**Official Transcript of Proceedings**  
**NUCLEAR REGULATORY COMMISSION**

Title: Advisory Committee on Reactor Safeguards  
NuScale Subcommittee: Open Session

Date: Thursday, June 20, 2019

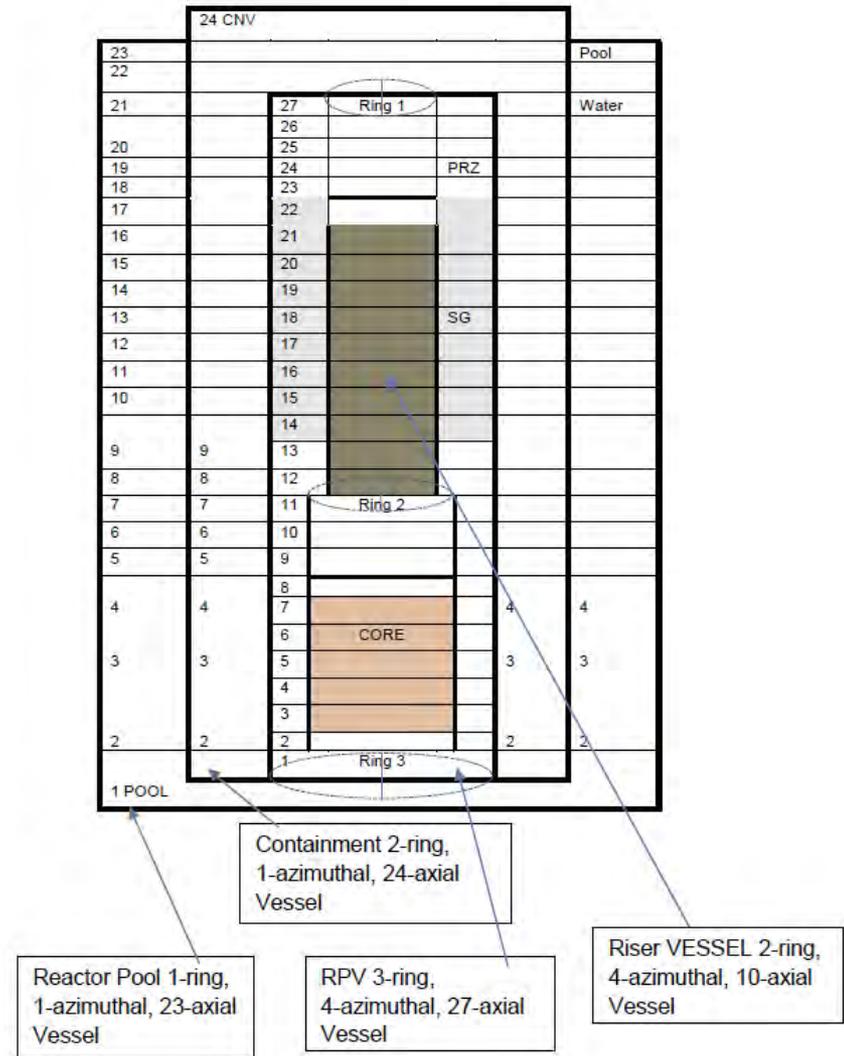
NuScale is developing LOCA TR markups to address the items identified above.

Staff is waiting on LOCA TR markups

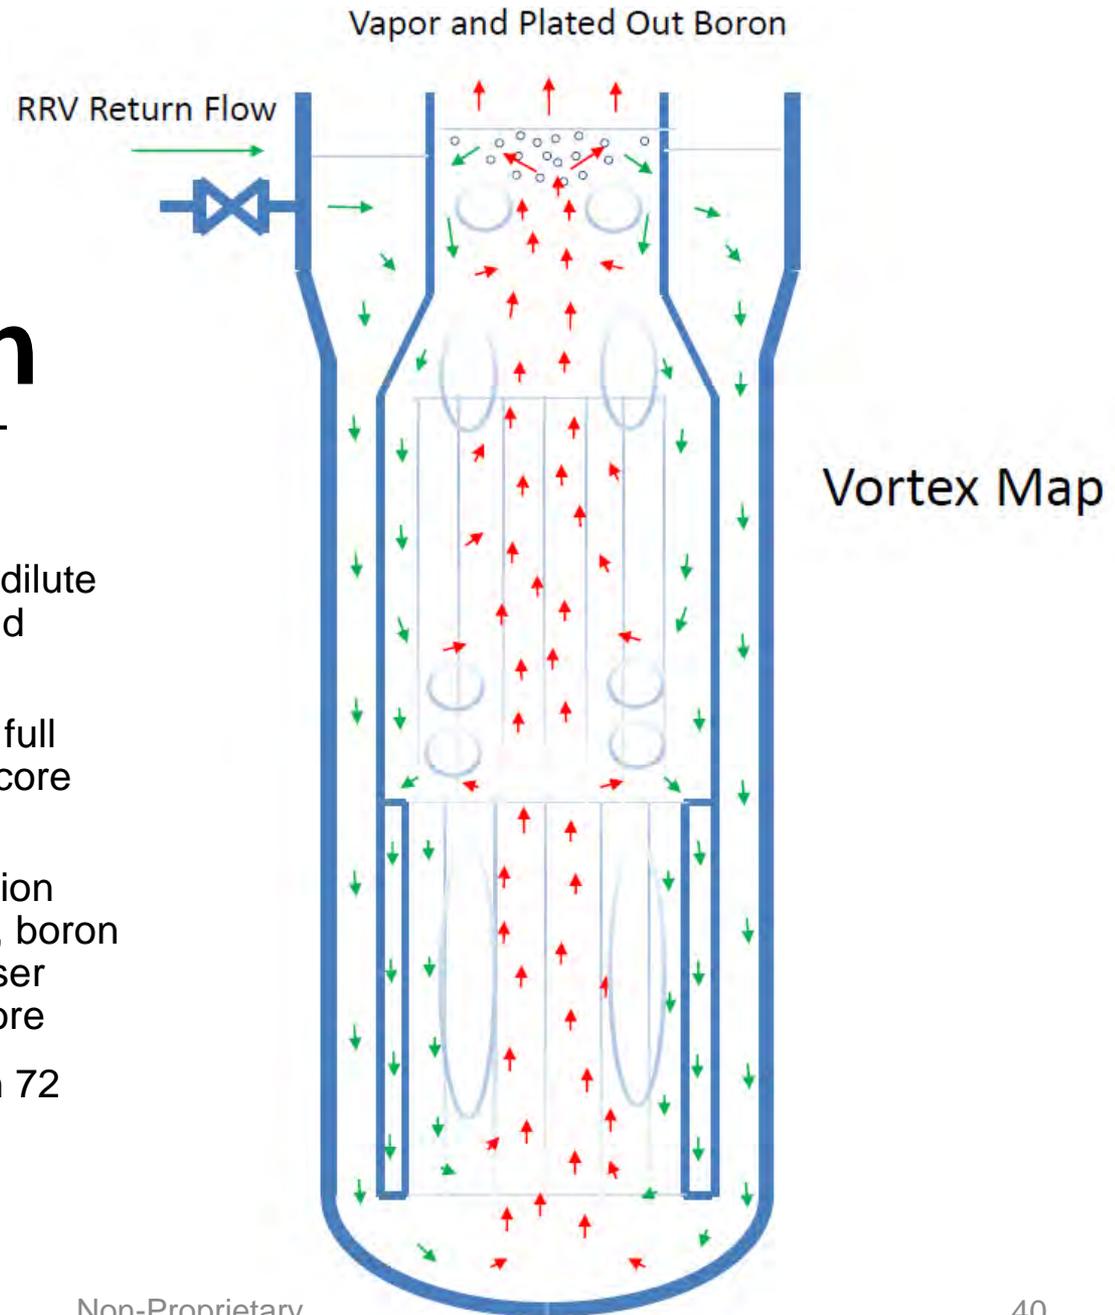
- NuScale predicted return to power under EOC conditions
- RAI 8930 was issued to address potential boron redistribution for the entire cycle and the potential for a return to power within 72 hours

A potential return to power could challenge CHF. The return to power could further accelerate boron plate-out resulting in higher power level, and this cycle could continue.

Figure 15.0-9: Analytical Operating Limits

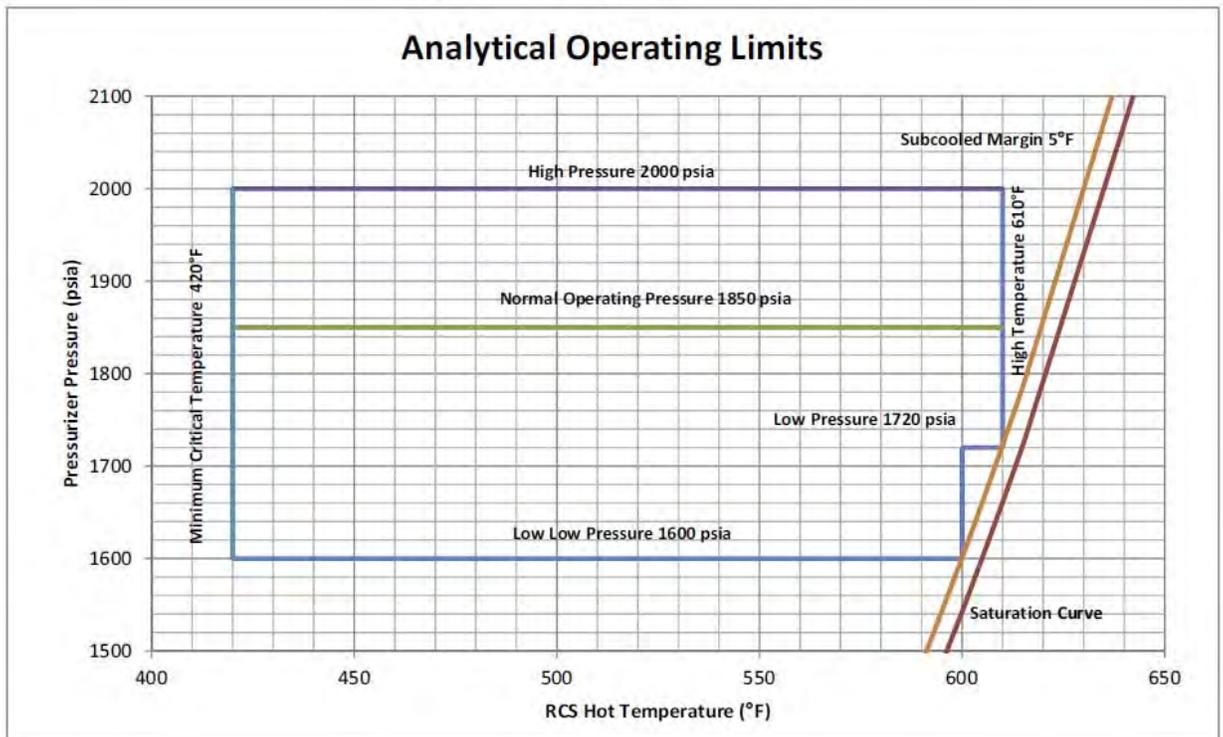
11. FSAR Figure 15.0-9 has this P vs T graph:

A typical PWR (at least a B&W plant) has an SPDS display such as this where RCS P and T plot in real-time and maintain the 'history trace'. It is an extremely handy tool for Operators to monitor and diagnose plant up-sets.

**Figure 5.1-2: Reactor Coolant System Simplified Diagram**

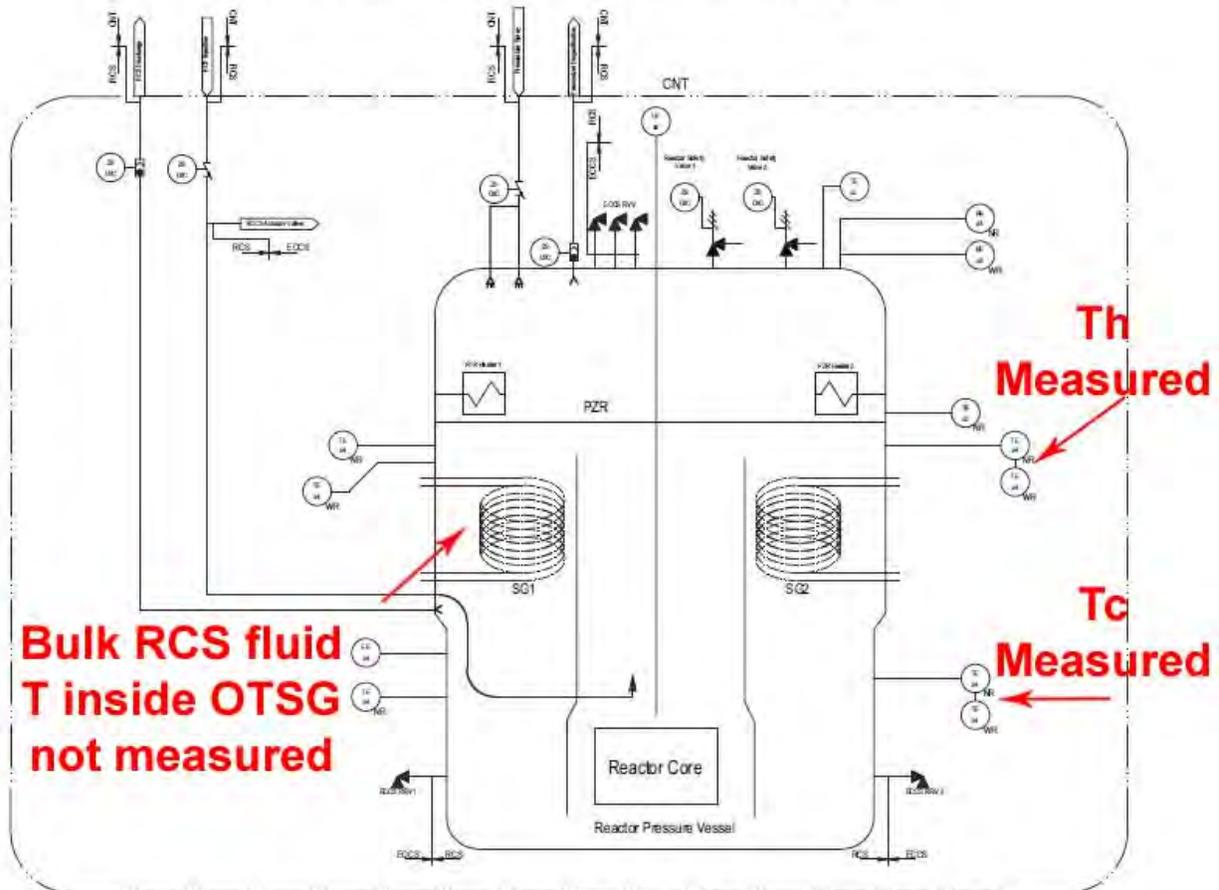
**Discussion of RCS response to a Reduction in MFW Flow, for a PWR with OTSGs.**  
 In a nut shell:

When the MFW Flow is reduced to an OTSG, and the Secondary Side water level starts to decrease (for NuScale OTSG, inside the tubes), the OTSG HT-X superheat region size starts to immediately increase in length. This means less heat is transferred **FROM** the bulk RCS fluid surrounding the OTSG tubes in that larger length HT-X region. Bottom line is the “cold side” T for natural circulation goes up. From just that affect, natural circulation flow rate has to go down. An extreme case example would be secondary side “dry out” from total Loss of MFW. In that case the RCS bulk fluid T around the OTSG tube bundle (inside the OTSG shell) would enter the OTSG shell at  $T_h$  and exit the shell bottom also at  $T_h$  since no heat would be removed inside the OTSG (the only OTSG HT-X region remaining would be a full-length superheat region.... I'll acknowledge it can transfer some heat).

Figure 5.1-3: Reactor Coolant System Schematic Flow Diagram

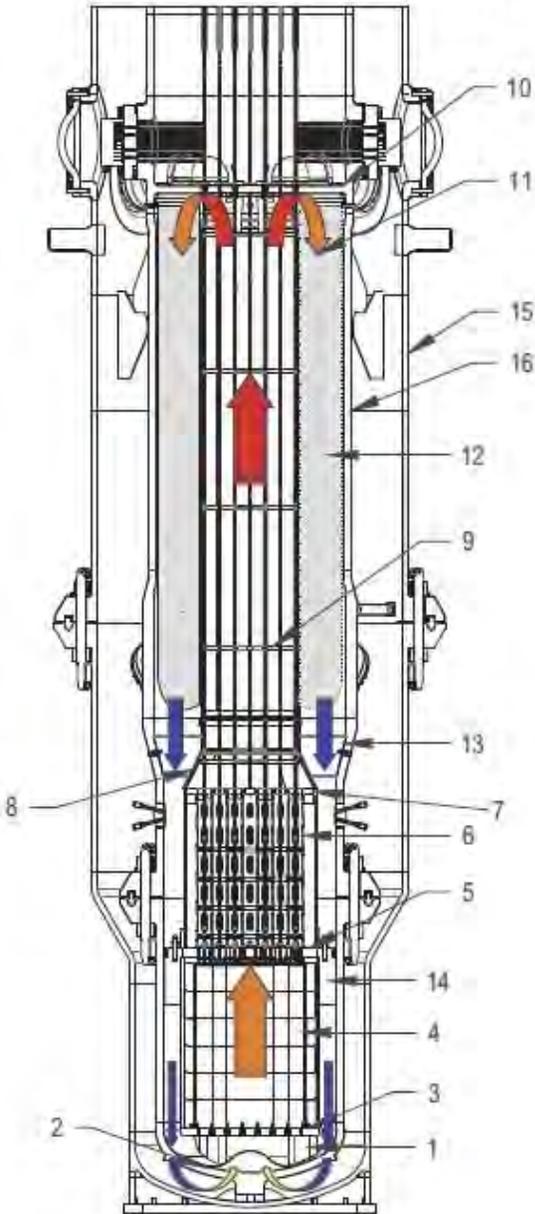
Th is measured up by #11, Tc is measured down by #13, the “cold side” T for natural circ is the T at #12 (not measured), the “hot side” T for natural circ is the T at the fat red arrow in the riser section. When MFW Flow decreases (or is totally lost as in the SA) and the RCS T at #12 starts to increase, the driving force for natural circ decreases and that flow must go down! Yet it is not discussed in the SA for “Reduction in MFW Flow”.

Figure 15.2-30: Reactor Coolant System Flowrate - Peak RCS Pressure Case (15.2.7 Loss of Feedwater)

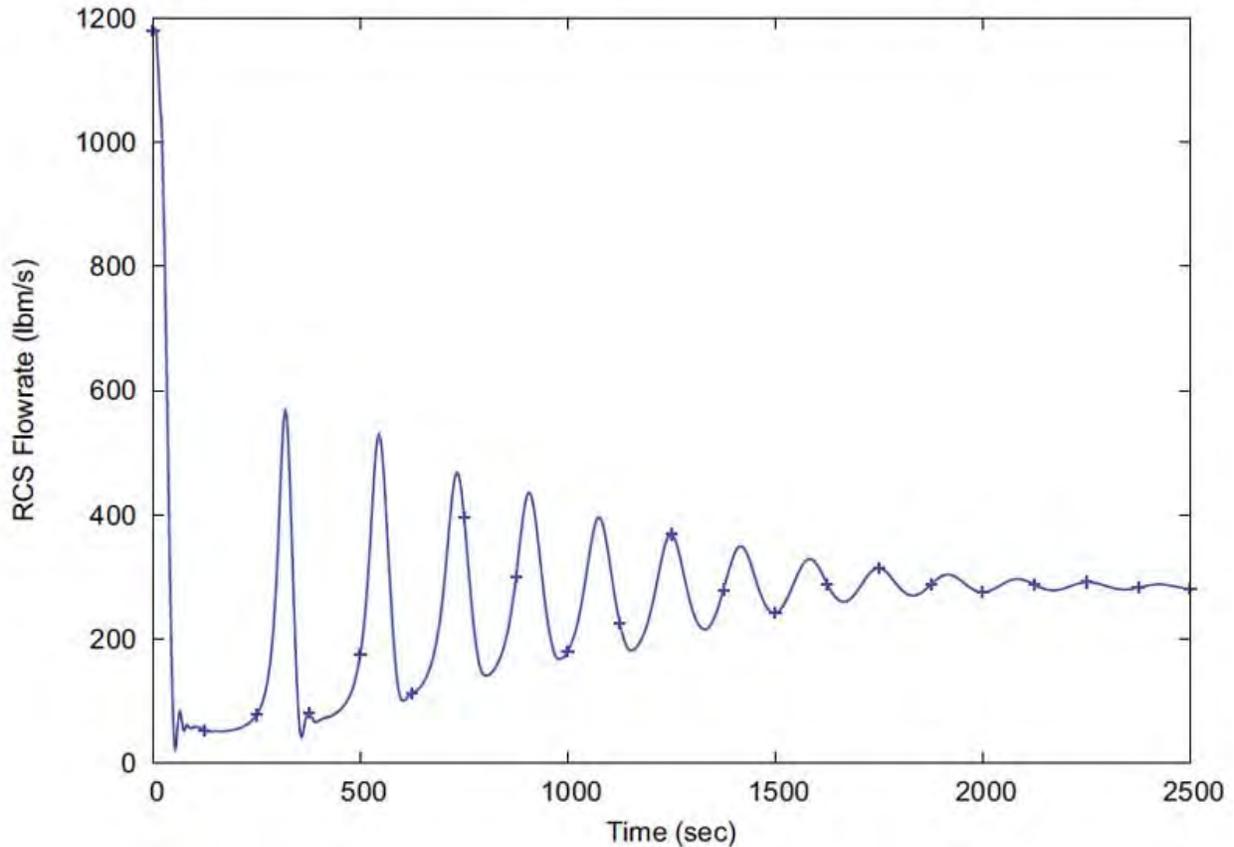
Further, FSAR Figure 15.2-30:

From **FSAR 15.2.7.3.3**:

“RCS flow (Figure 15.2-30) drops initially due to the reactor trip and stabilizes as DHRS flow is established.
